**Calaveras County Water District
Copper Cove, California
Bidding Documents
Copper Cove Phase 1 and 2 Tanks Project**

**ADDENDUM NO. 2
Issued August 3, 2023**

COPPER COVE WATER SYSTEM IMPROVEMENTS PROJECT - PHASE 1 AND PHASE 2 TANKS

EXISTING CLEARWELL SITE PLAN

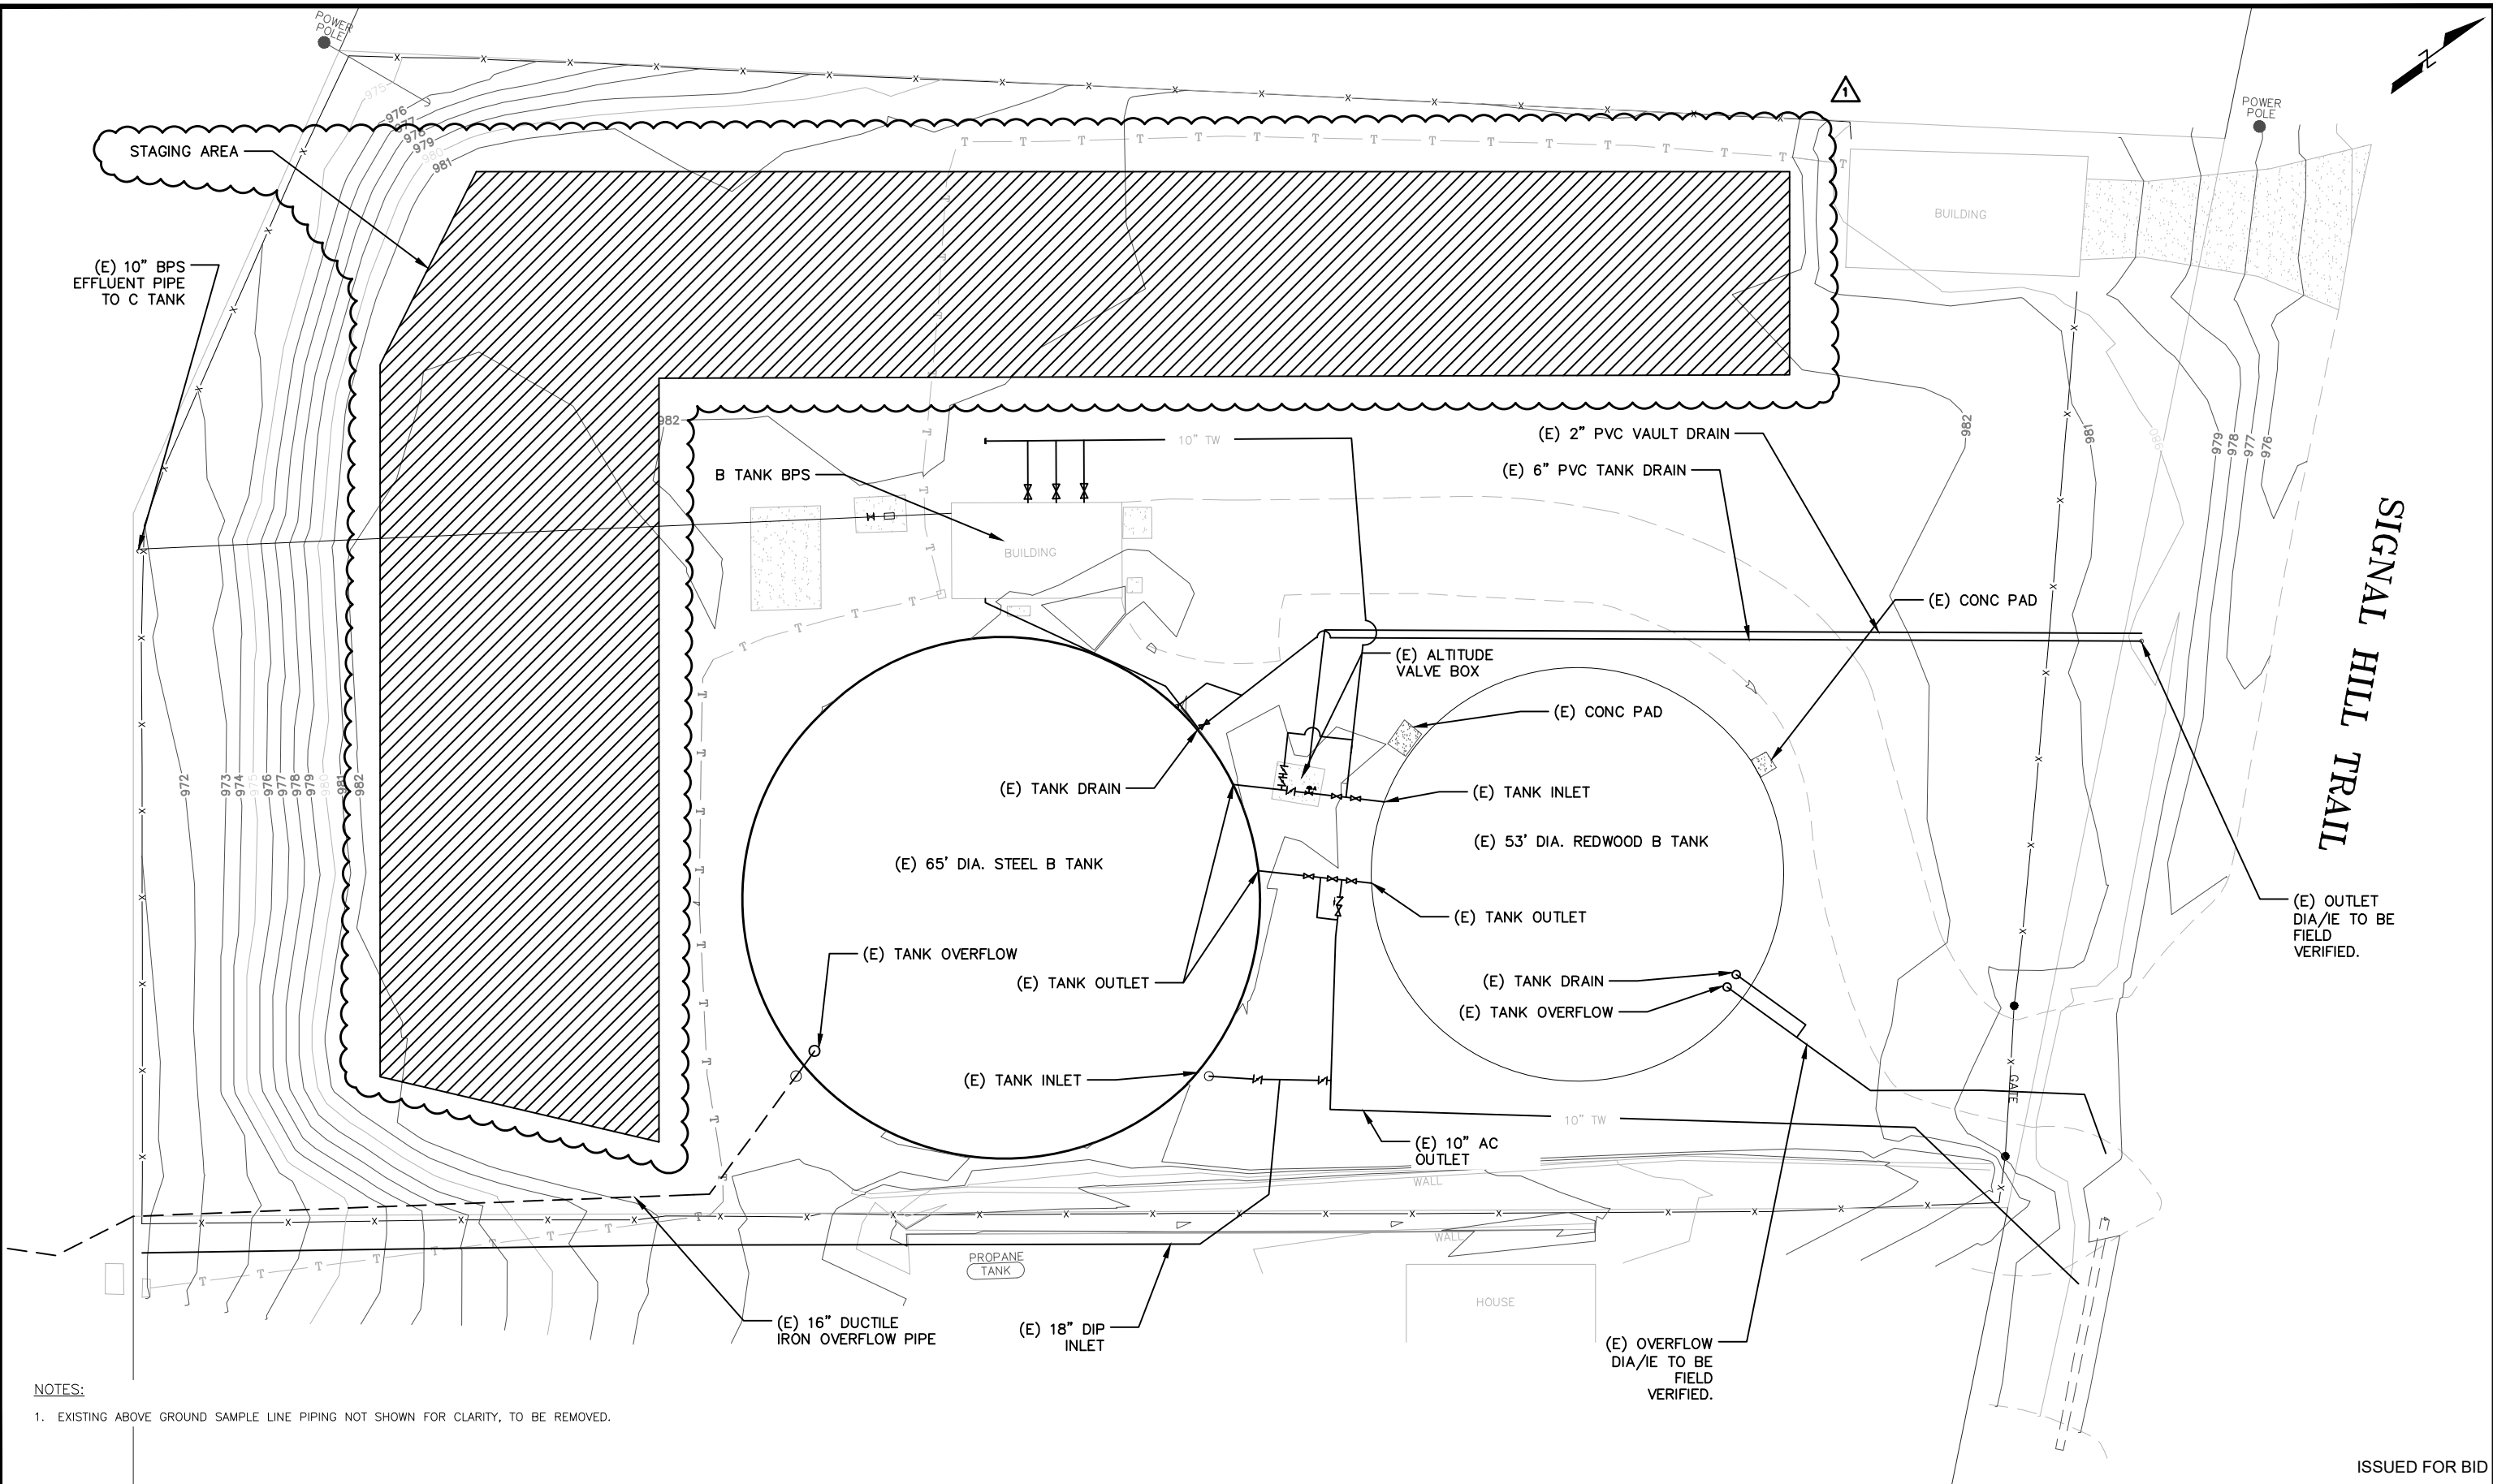
- 1) Replace C1, C2, C5, and C7 with the attached revised sheets in attachment A.

EXISTING B TANK SITE PLAN

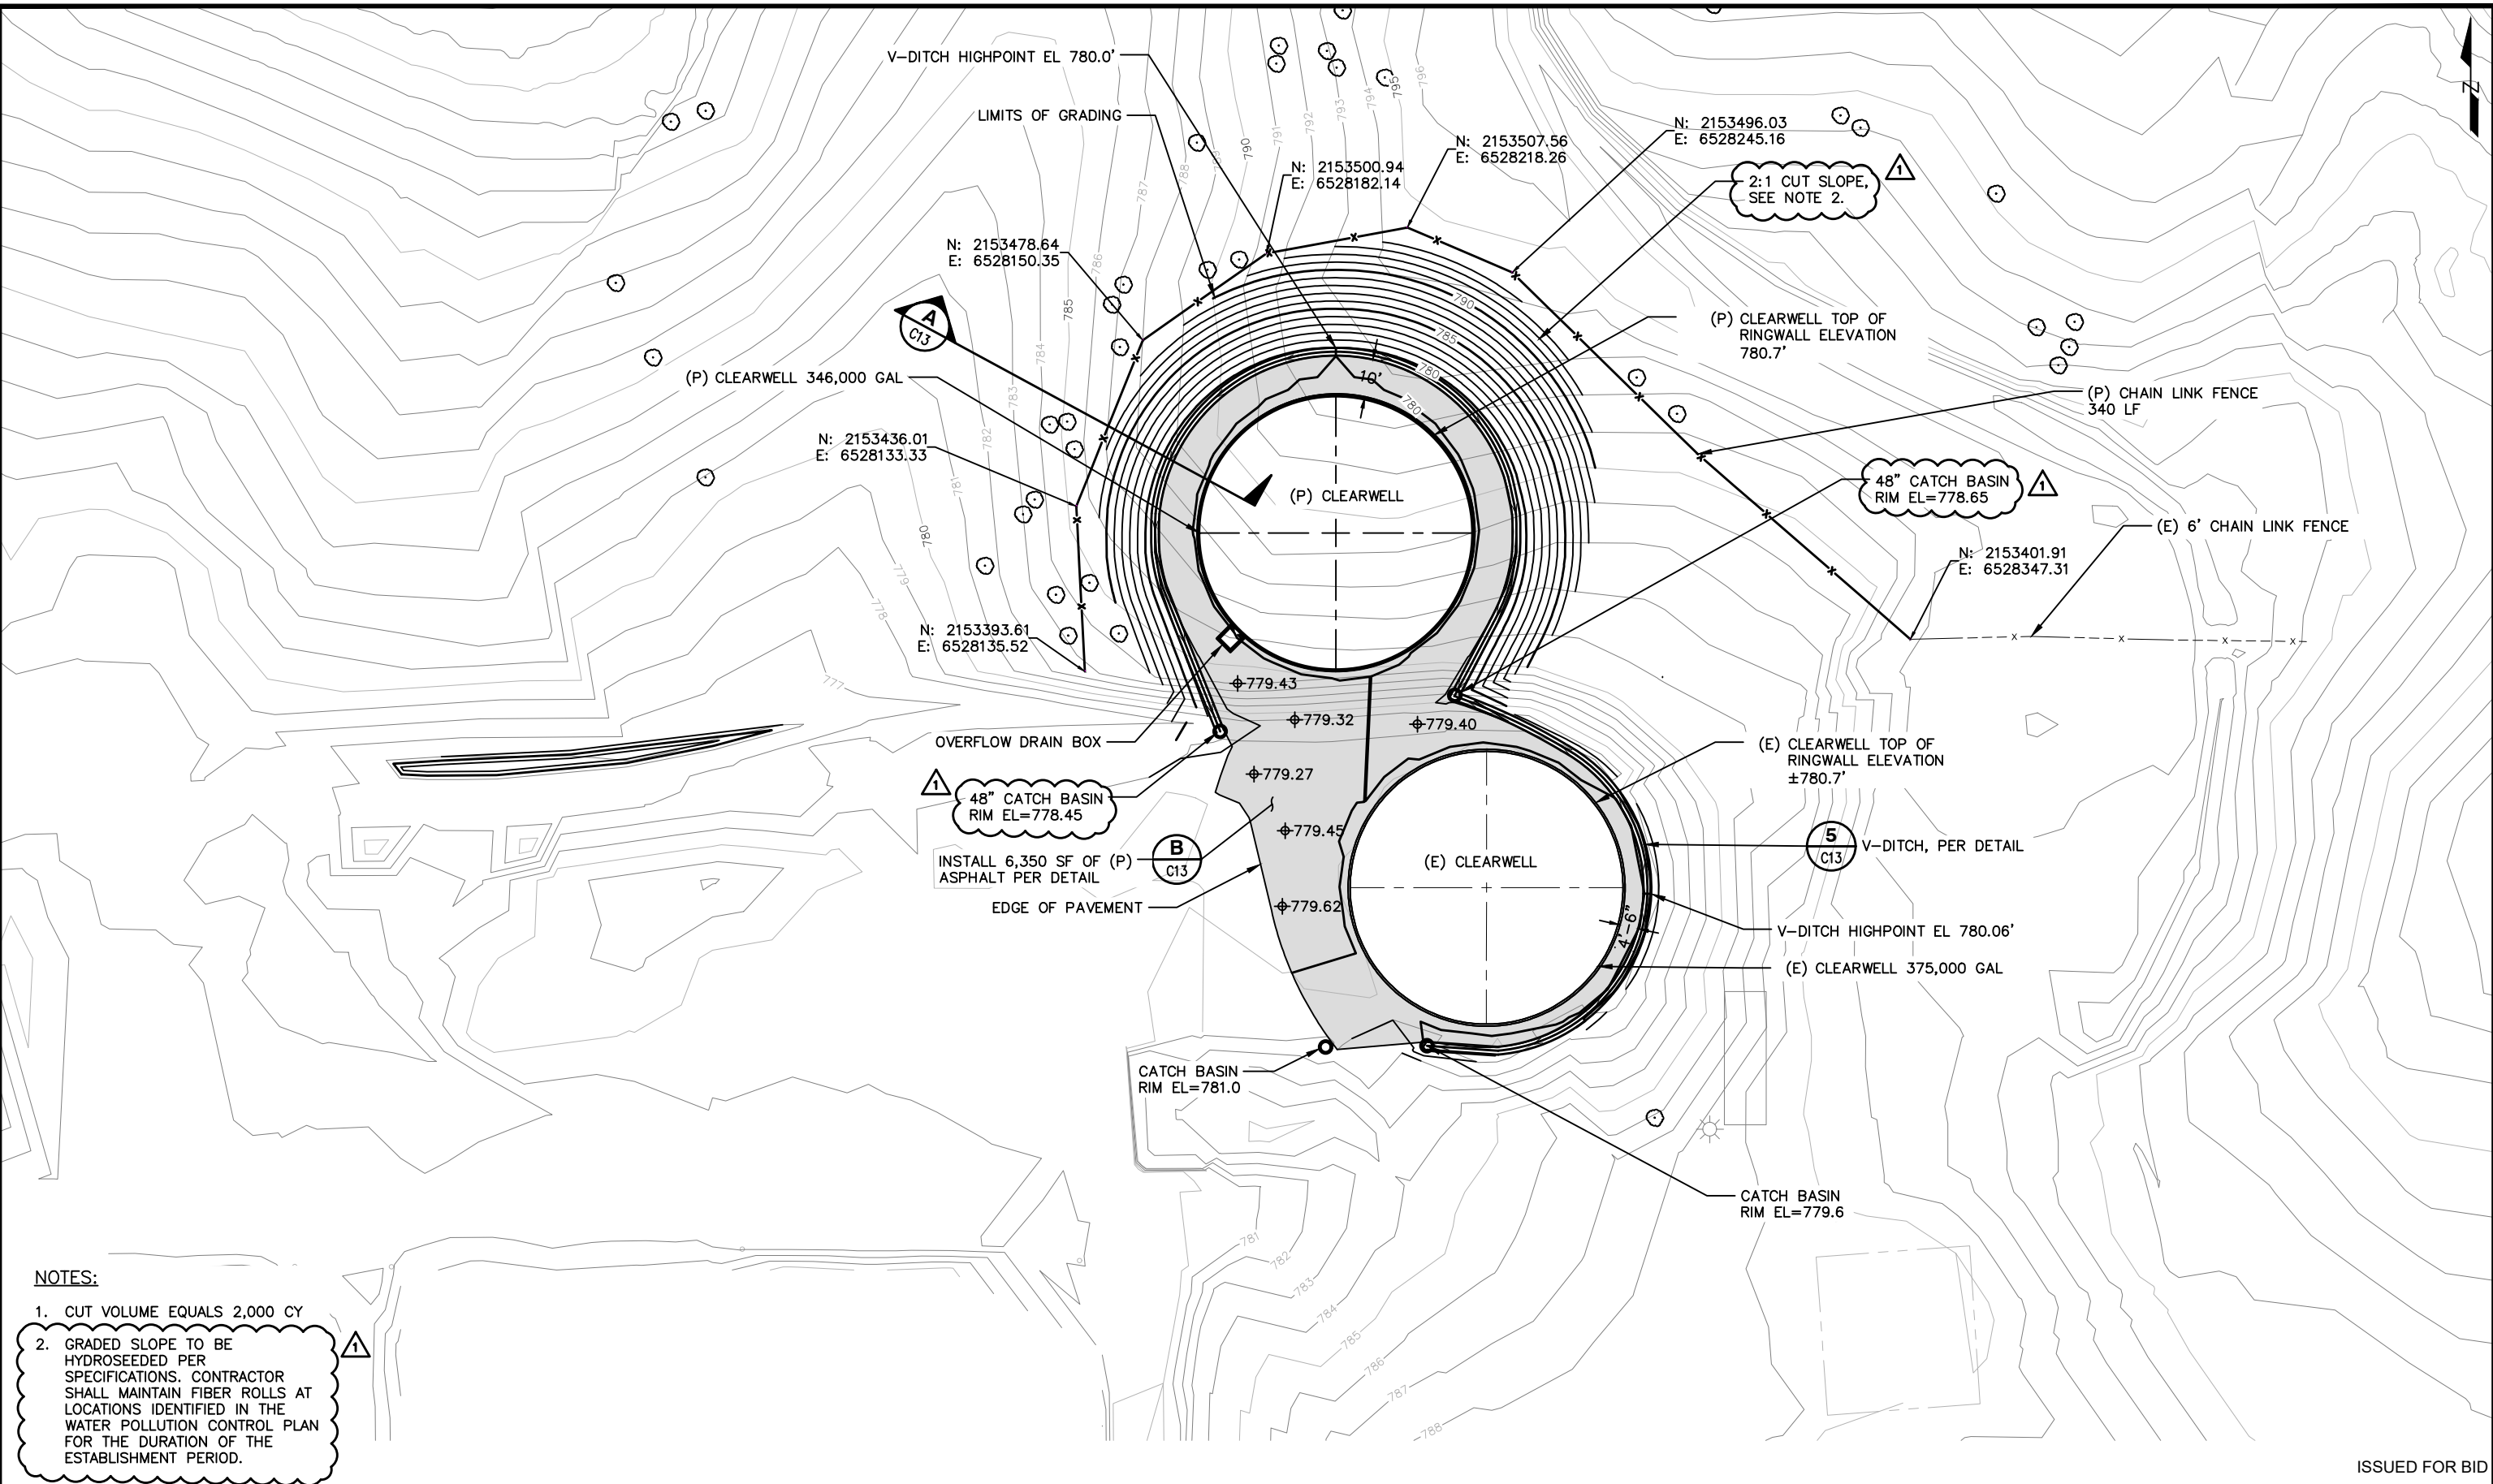
NOTES:
 1. EXISTING ABOVE GROUND SAMPLE LINE PIPING NOT SHOWN FOR CLARITY, TO BE REMOVED.

CLEARWELL TANK SITE GRADING PLAN

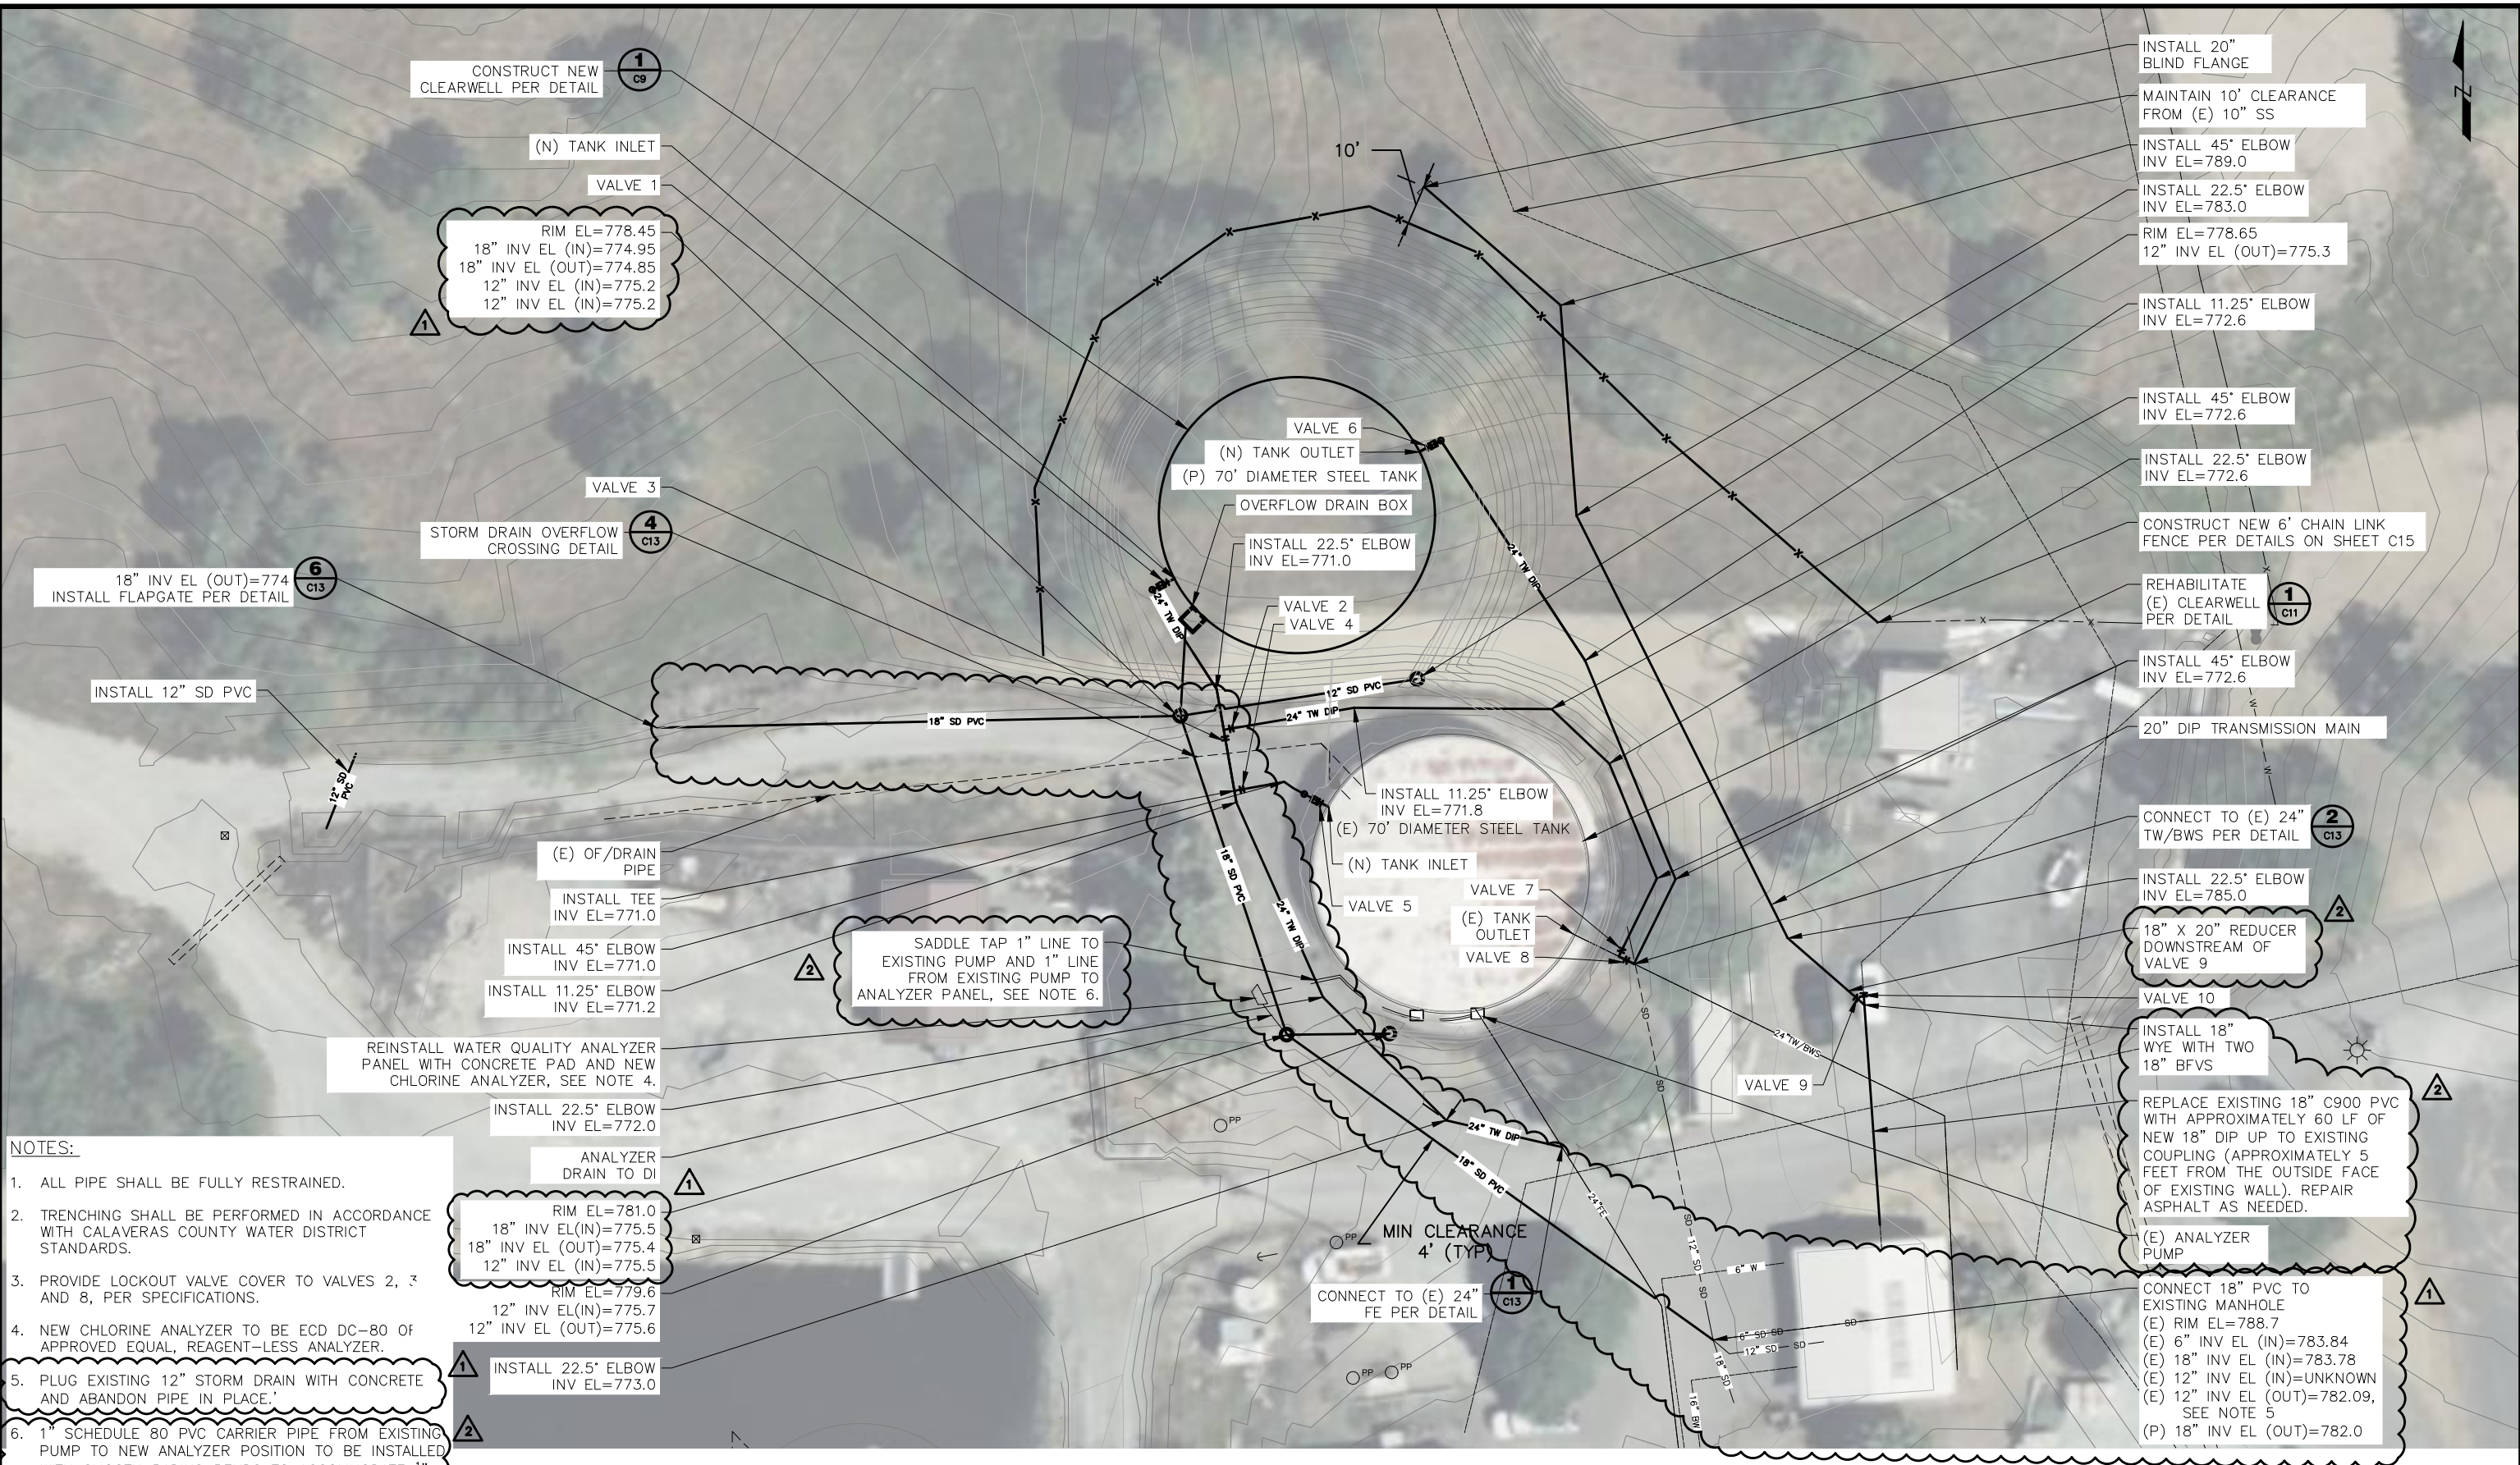
- CUT VOLUME EQUALS 2,000 CY
- GRADED SLOPE TO BE HYDROSEEDDED PER SPECIFICATIONS. CONTRACTOR SHALL MAINTAIN FIBER ROLLS AT LOCATIONS IDENTIFIED IN THE WATER POLLUTION CONTROL PLAN FOR THE DURATION OF THE ESTABLISHMENT PERIOD.
